Product Change Notification (PCN)

PCN Number	510586	Date Issued	August 09, 2021
Reason for Change	Change to Product		
Change Type Description	This letter is to inform you that changes are being made to the part(s) identified in this Notice. The change may affect the fit, form, function or appearance of the parts, or it may result in a change to the specification. The details below show an example of the possible differences.		
Reason for Short Notice	Special Request		
Assessment of Change	Product will be fully qualified before it is shipped. Qualification reports will be available after below listed date		
Internal Molex Qualification Date	July 21, 2021		
Sample Availability Date (Changed Part)	July 21, 2021		
Planned Implementation Date	September 09, 2021		
Method of Identifying Change	Date code

204926 Micro USB receptacle Overview

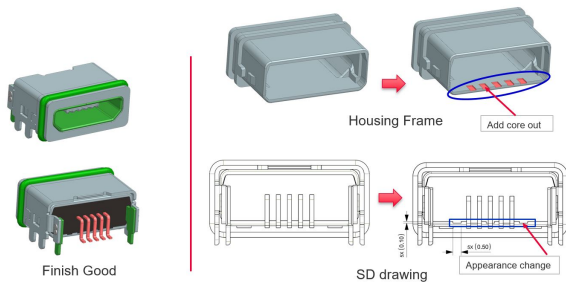
— Before and after the change: Add Core out for housing frame

- Change description:
To optimize the product structure to add core out for housing frame to improve the warpage and increase bonding strength.
- Product impact
No impact to fit, form, function from the change.
- Part Number Impact
— 2049261103, 2049261104 as the IAR.
- Qualification Reports and samples available upon request after the date shown above
— 2021/07/30
